Site Data

Concept Data

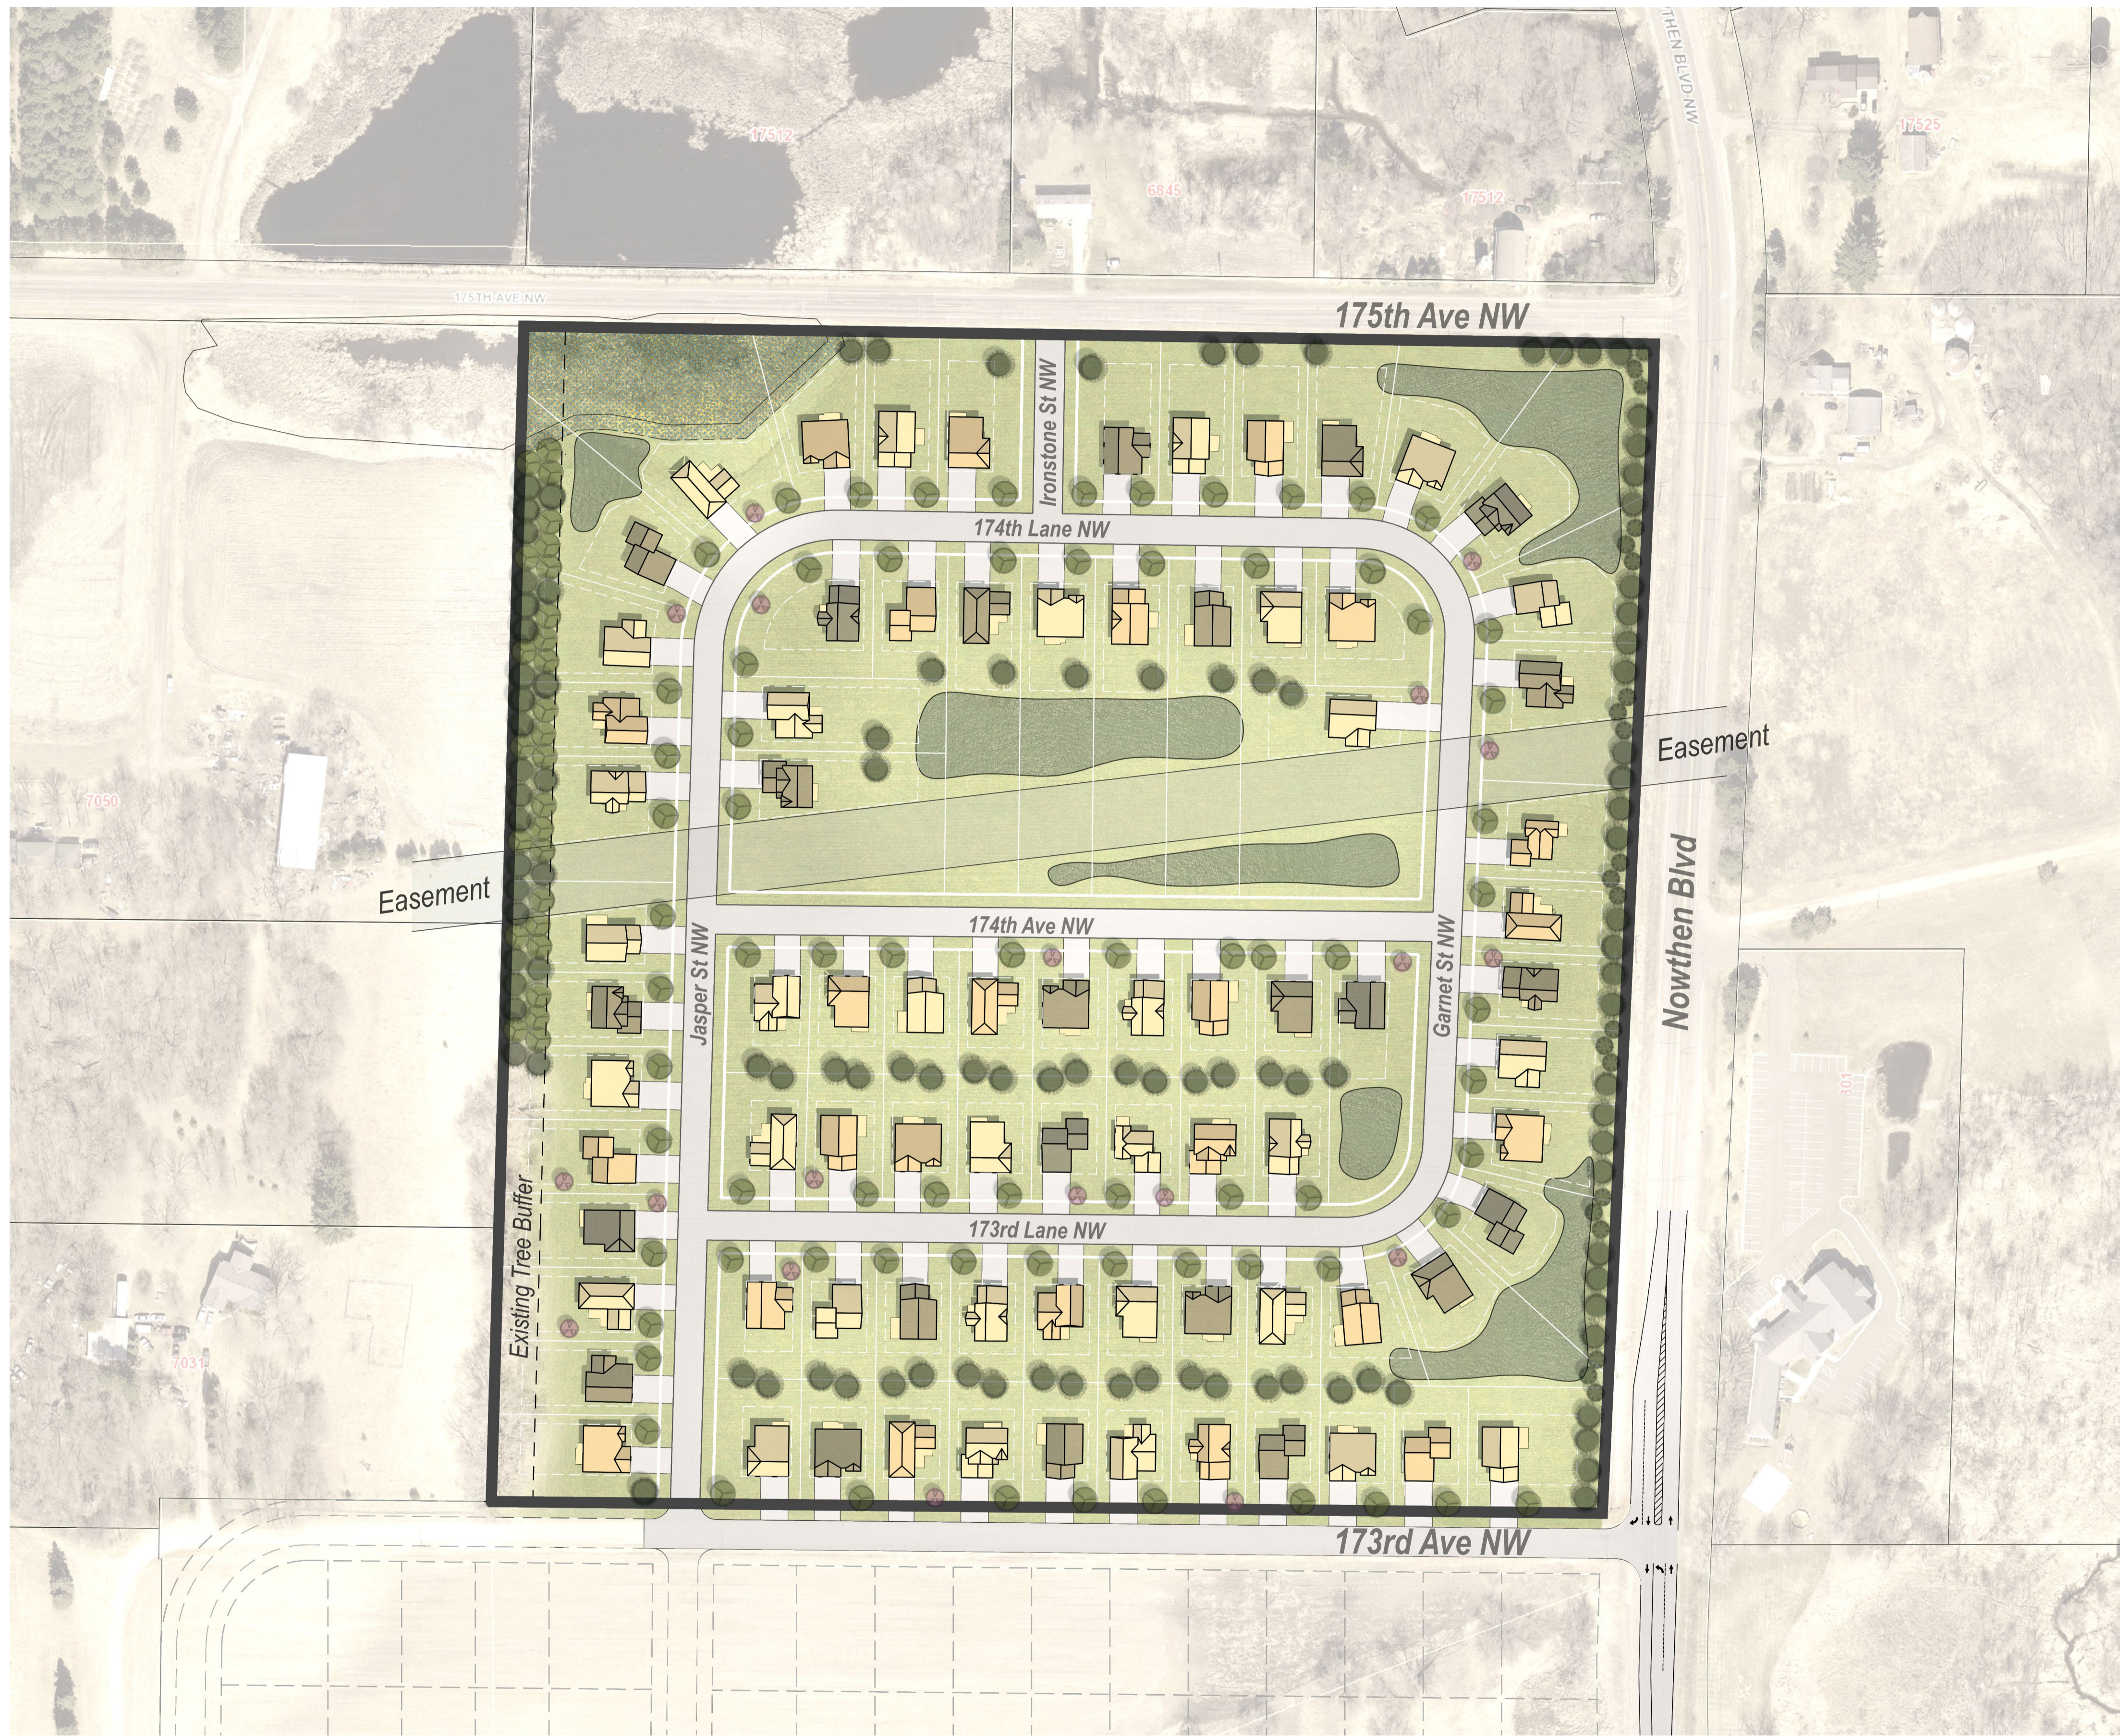
173rd Avenue will need to be upgraded to urban street standards. Will discuss Cost Share/Assessment Agreement with other benefitting properties (benefitting by future development, not assessed to existing residents).

Shift intersection south to improve width of ROW. Preserve additional ROW on south side of 175th Avenue NW.

Due to access onto 2 collector roads, a traffic study shall be required.

Please work with City's Engineering Division to develop a revised plan for Trunk Utilities to service this site. 2018 Comprehensive Water and Sewer Plans are baseline for discussion. Plan prepared by Bolton and Menk.

Potential layout change to eliminate some of the dead space along the easement.

Trunk utilities do not exist to this site. Development will require extension of utilities. Options will need to be discussed. Consideration of a temporary lift station until trunk sewer line from the west is constructed may need to be considered.

Upgrades to adjacent streets will be required with development. These upgrades will need to be shown at time of preliminary plat to confirm right of way at 173rd and 175th is sufficient for necessary improvements.

Stormwater ponds are shown on the sketch plan. This site minimal grade change from west to east and north to south. The proposed stormwater ponds are on the east and north edges of the site. The properties east of Nowthen Blvd and north of 175th Avenue do not have drainage and utility easements for routing stormwater.

The preliminary plat plans will need to show the proposed outlet routes with proposed easements from the ponds to the county ditch north or east of the site.

The City has recieved high water complaints in the past from the properties north of 175th Avenue. Stormwater cannot be directed north without investgation of the drainage system in that area.

Multiple connection points will most likely be required due to the Natural Gas lines that cross the site. Providing the require separation between storm sewer and gas lines is probably not feasible.

The narrative talks about floodplain mitigation to allow constuction of the lots in the northwest corner of the site.

The floodplain bououndary was not established with detailed methods. The watershed for this floodplain extends into the City of Nowthen. Identifying the floodplain elevation in this area and sites for floodplain mitigation will take some effort that is not generally part of preliminary plat approval.

The nearest Municipal Sewer and Water Lines are near the intersection of Trott Brook and Variolite Street. A plan for connection to these services must be developed. It must be thoughtful, providing service to this site while preserving the development potential of the lands which the lines must cross.

A concept for connection to municipal sewer and water must be included in the preliminary plat submittal.

In the NW corner (impacting lots 36-40), the floodplain is designated General Floodplain District, meaning the floodway/flood fringe boundary has not been determined by FEMA. City Staff has reached out to the DNR to see if any regional flood elevation and/or floodway data is available to assist with this determination. Applicant may have to complete a hydrologic and hydraulic engineering analysis to determine Regional Flood Protection Elevation.

Lot 77 as shown does not appear to meet the minimum lot size.

Note that lots 69 and 79 do not have 80 feet of continuous width due to the easement.
